**ADMINISTRATIVE AMENDMENT**  
 File # 09AA-105A Project # 1000572  
 Addition of single-family, detached product. Delete 36 condo units and replace with 24 single-family units.  
 Russell B. Bingham 26 June '09  
 APPROVED BY DATE

**AMENDED SITE DEVELOPMENT PLAN FOR PRD THE PRESIDIO**

PROJECT # 1000572

**THE PRESIDIO UNIT 1,  
REPLAT OF TRACT J  
CENTEX HOMES**

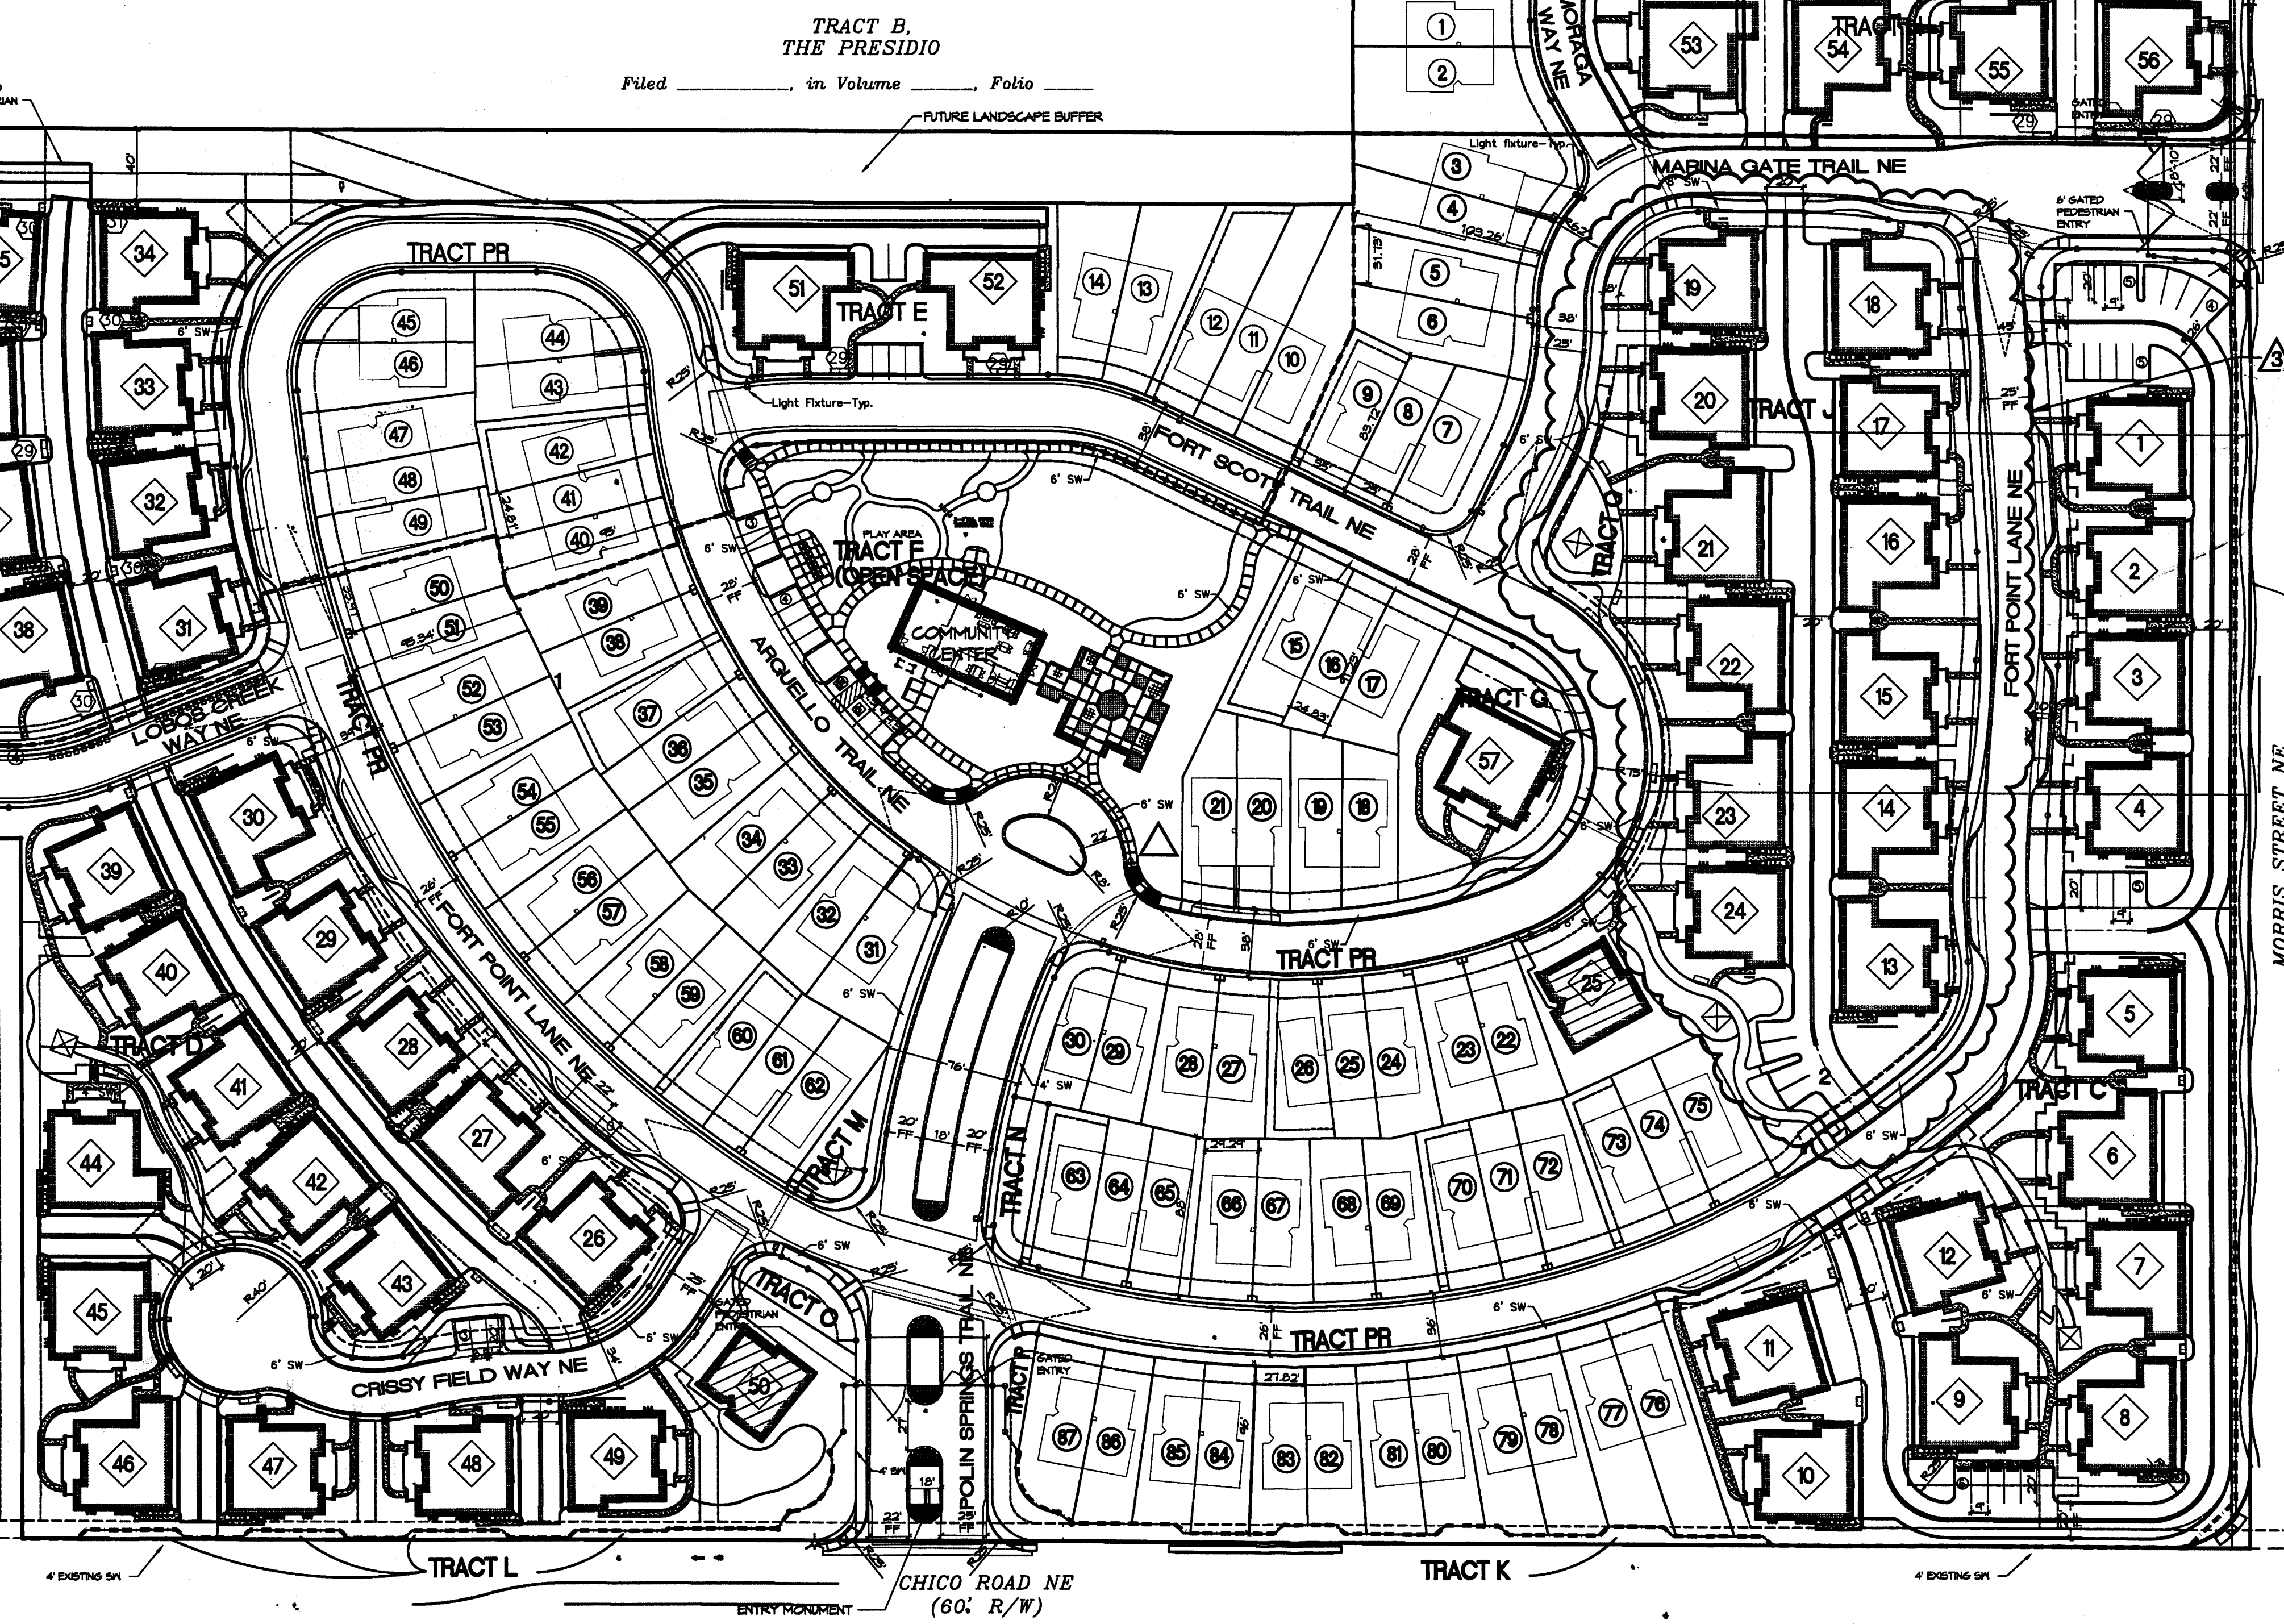
- 5.) Buildings 25 & 50 are ADA compatible.
- 3. Amendment: June, 2009
  - 1.) Add a new single family product to the project sheet 2.
  - 2.) Modify Tract J, delete (12) condominium buildings (36 Units) and replace with (24) single family houses. This may be implemented in phases (minor plats).

UTILITY PLAN FOR 8 SINGLE-DETACHED UNITS  
1"=20'

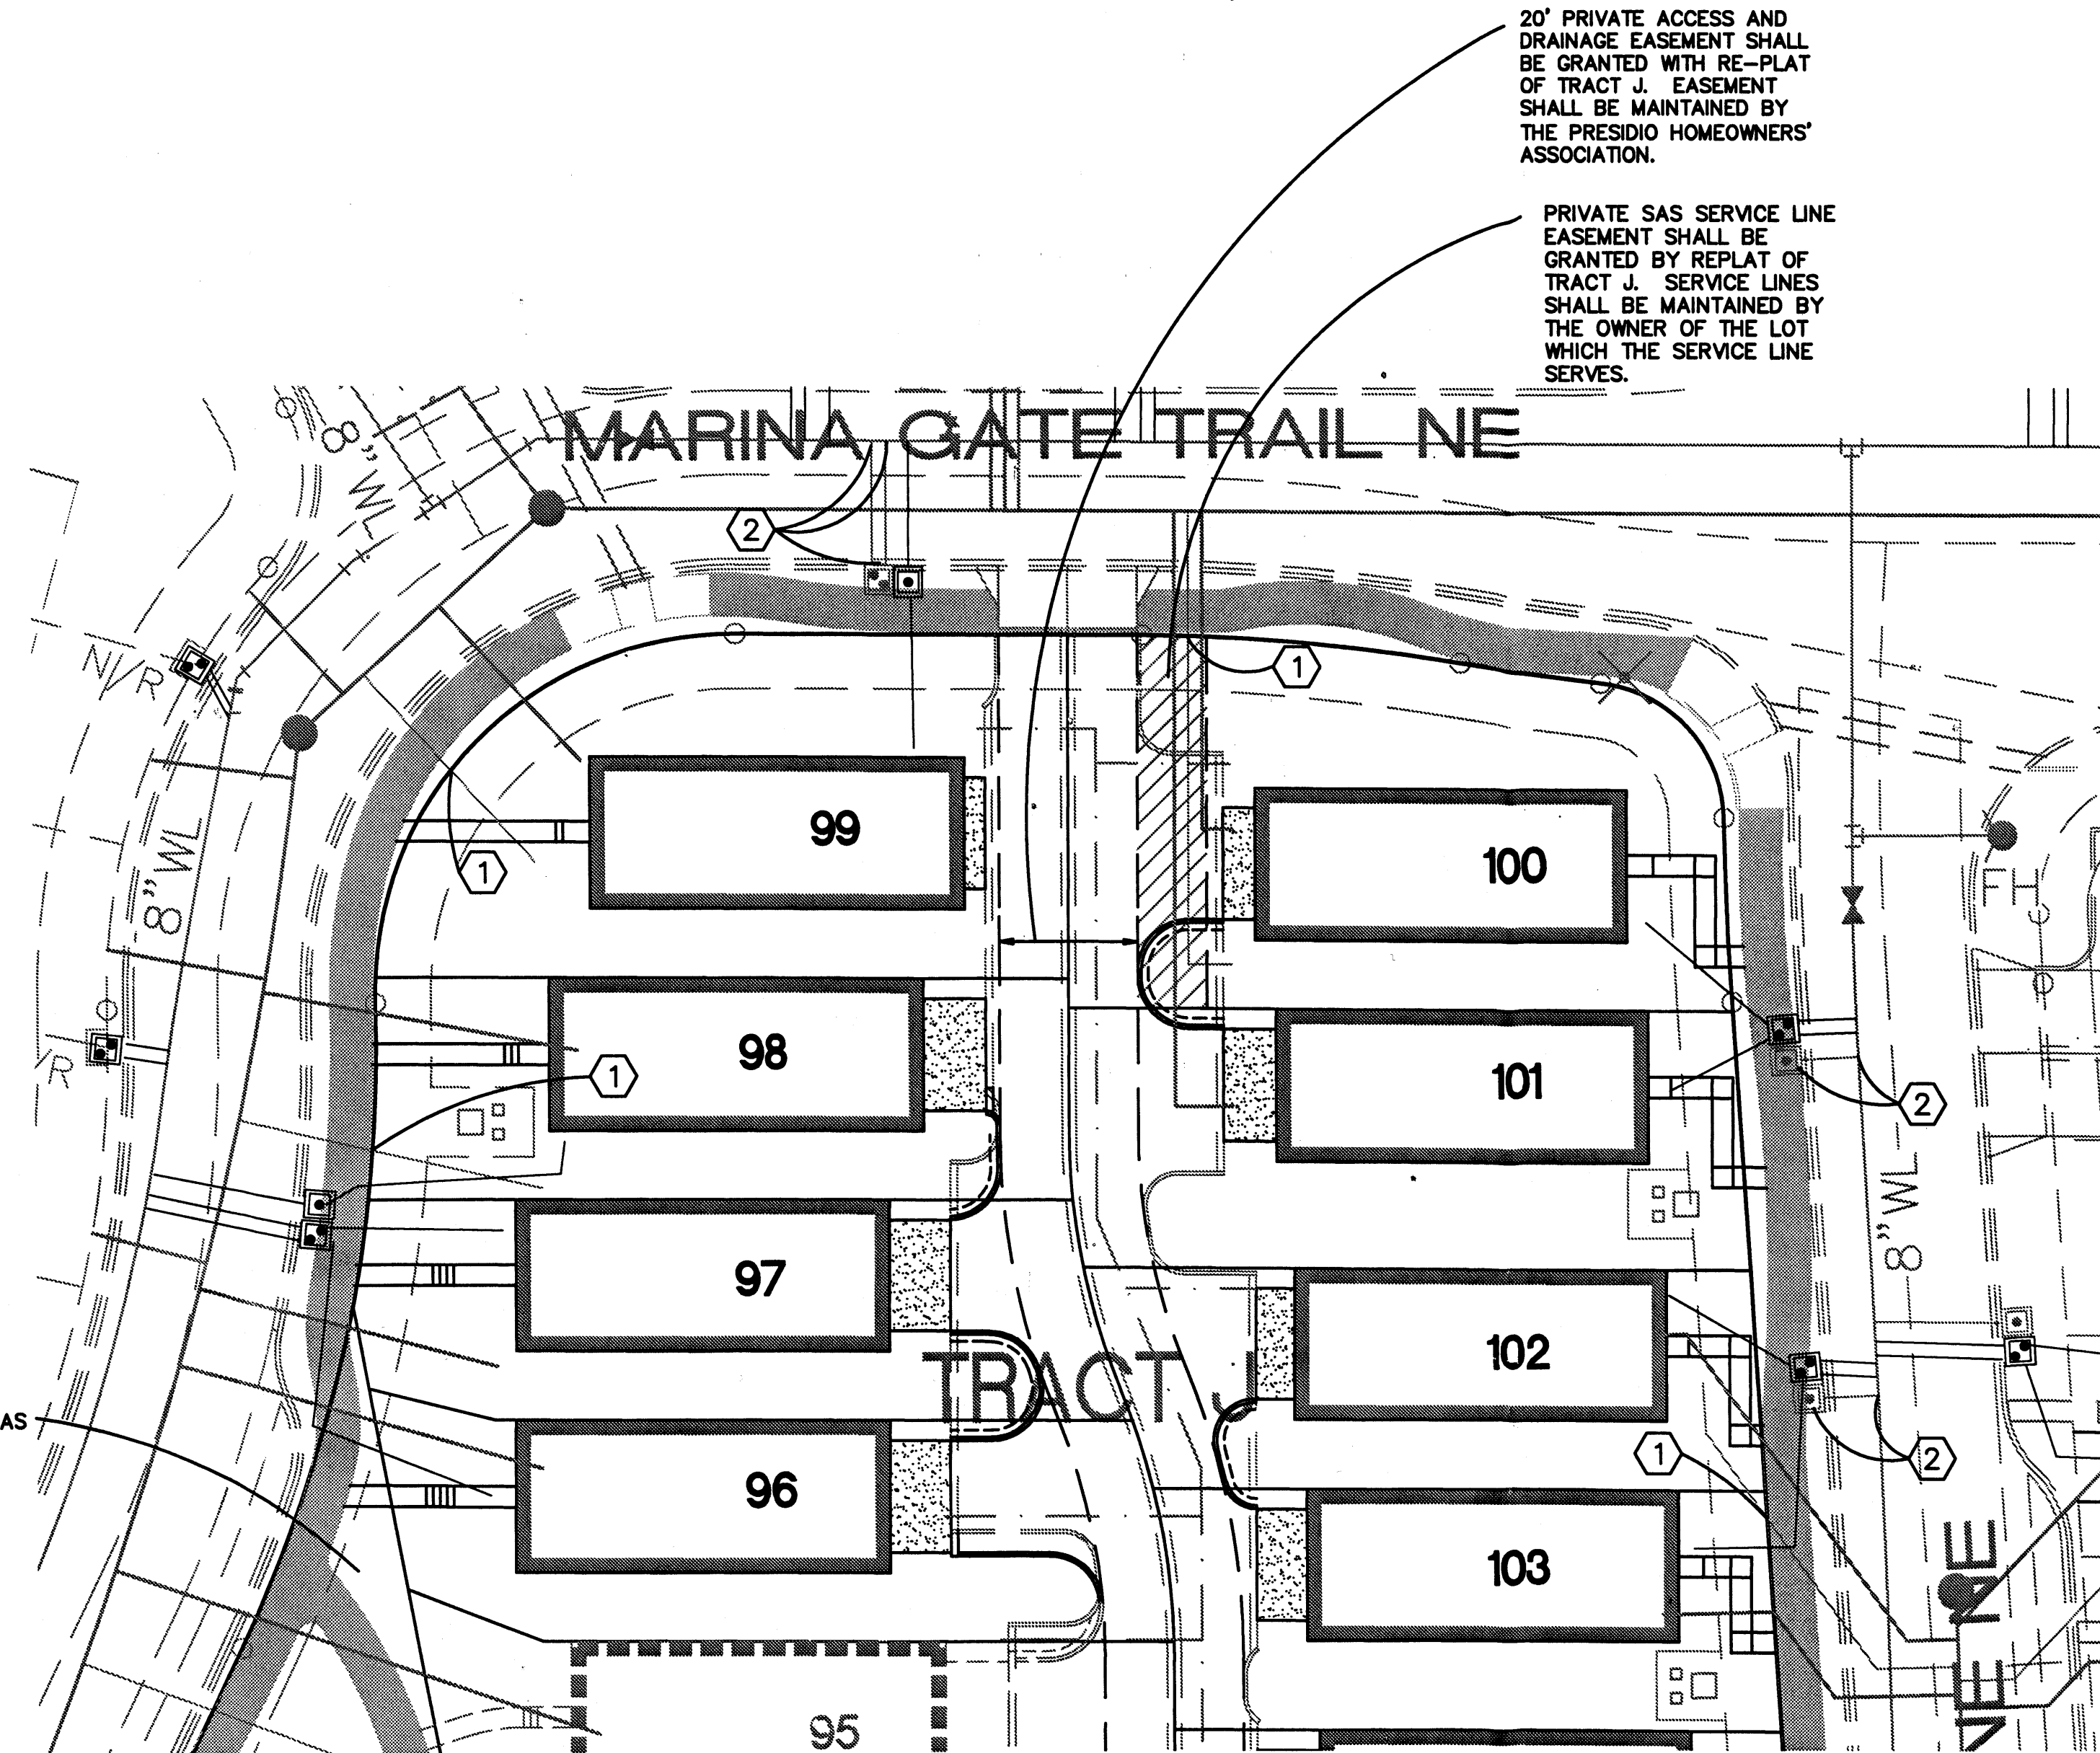
THE PAVING, CURB AND GUTTER (PRIVATE STREETS & ALLEYS), AND PUBLIC WATER AND SANITARY SEWER LINES AND SERVICES WERE INSTALLED WITH THE PRESIDIO, UNIT 1 PLANS—CPN 797481. 12 TRIPLEX CONDOMINIUM BUILDINGS (36 UNITS) SHALL BE REPLACED WITH 24 SINGLE DETACHED LOTS IN 3 PHASES.

THE EXISTING WATER AND SANITARY SEWER SERVICES SHALL BE USED FOR THE NEW SINGLE-DETACHED UNITS.
